## 11301A FIRMWARE REPLACEMENT

11301A      All Serial Numbers

## MANUAL CHANGE INFORMATION

Date: 18-Jan-90 Change Reference: M70209 Rev-1

Figure 2. - EPROM locations, Main Processor ckt bd A11

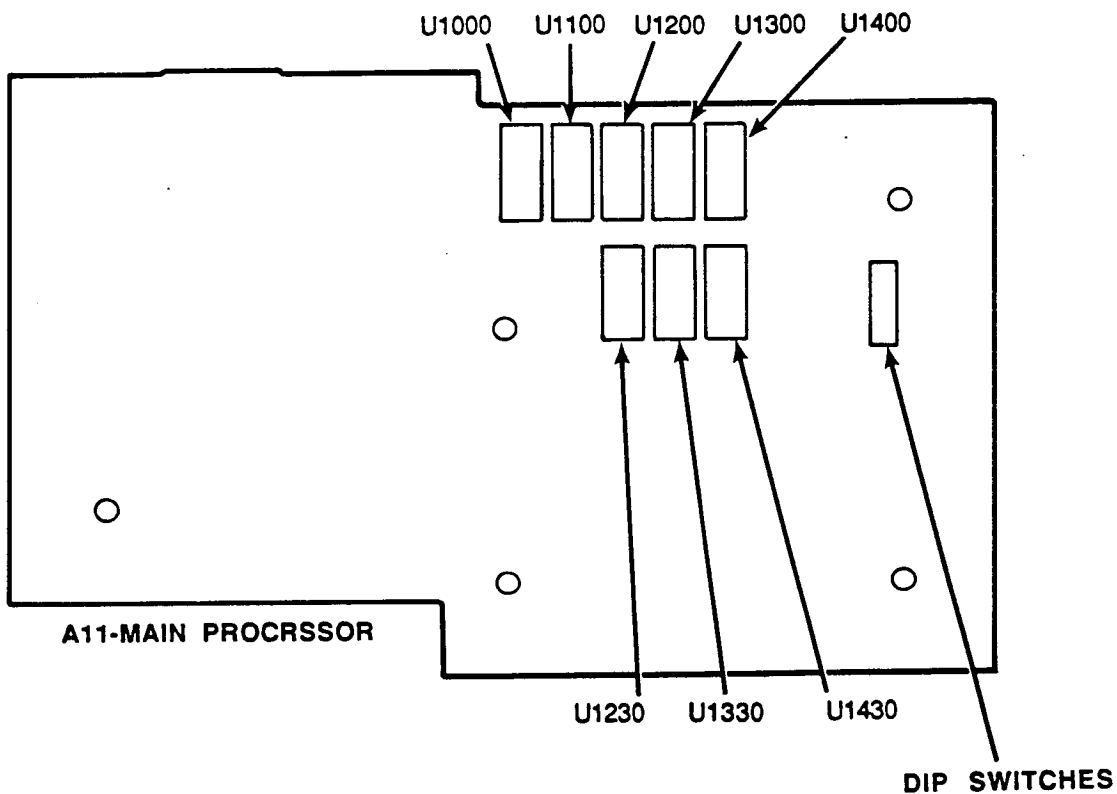
- 3. Replace U1000, U1100, U1200, U1230, U1300, U1330, U1400, and U1430 with the new EPROM's that are provided in this kit. Refer to Figure 2, for EPROM locations.

Figure 2-74. Measurement choices shown above.

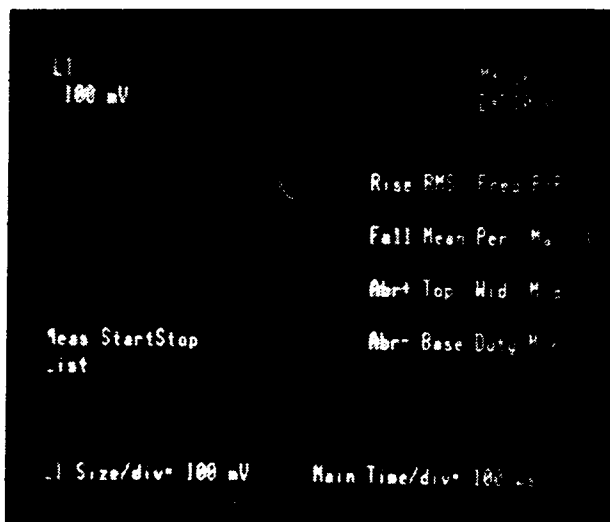
Add this new display to page 2-151:

The MEASURE major menu display has been changed as shown below:

Figure 2-79. Non-volatile stored settings menu selections.

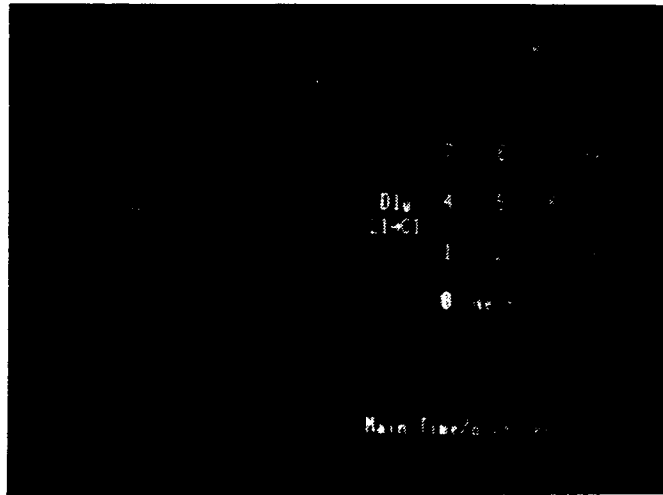
Add this new display to page 2-162:  
The STORE RECALL major menu display has been changed as shown below:
